**ELECTROLUX HOME PRODUCTS PTY LTD**

**Technical Bulletin N° CB1021**

## Noise or Vibration

## Panel deck before serial number 73400000

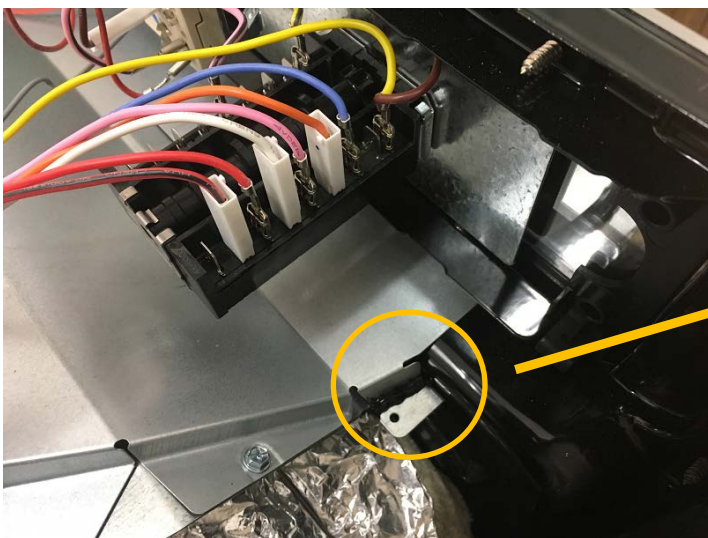
Due to the large panels used in the cooling fan duct, there is a possibility some vibration and noise can be generated in this area.

Applying some silastic (Part N° 0393 001 065) in the areas shown will stop this possibility.

1. Remove the hob

2. Apply silastic in these 2 places.

3. Apply silastic to both sides.

### Oven fan motors before serial number 74100000

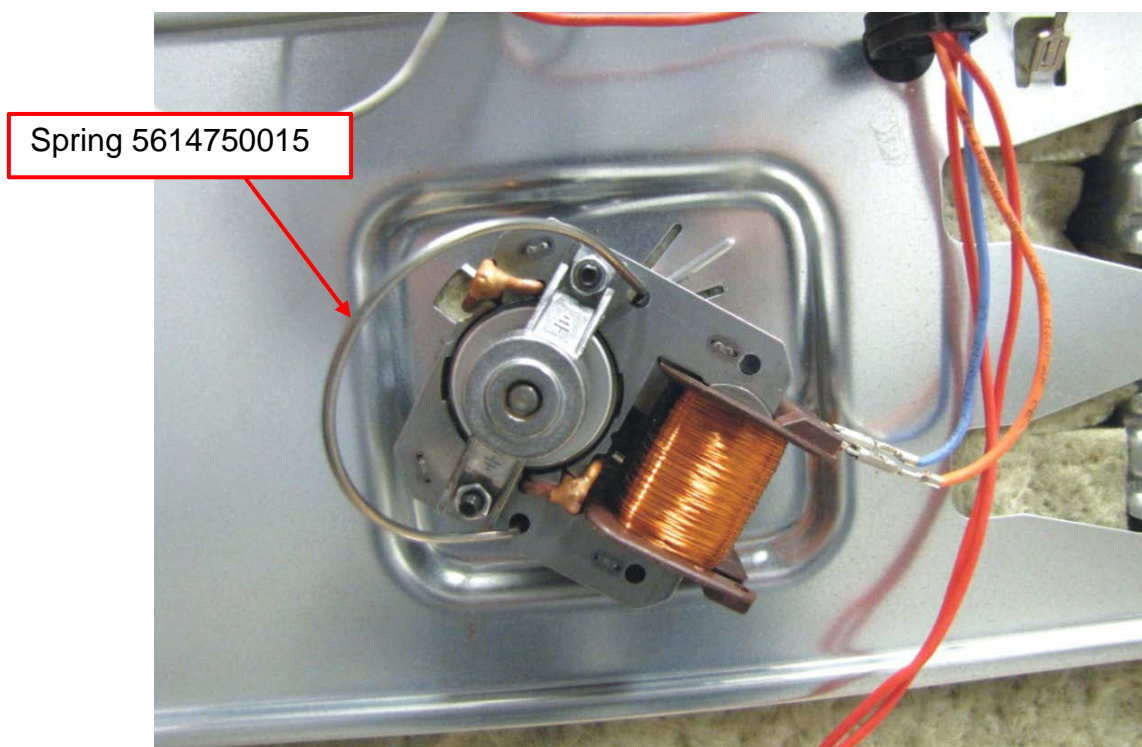
A noise can be heard at start up or when the oven is hot while using fan element cooking.

When the fan motor is running it produces a magnetic field which can cause vibrations therefore creating noise on the back panel of the oven.

A spring (Part N° 5614750015) should be fitted to the motor as shown in the picture below.
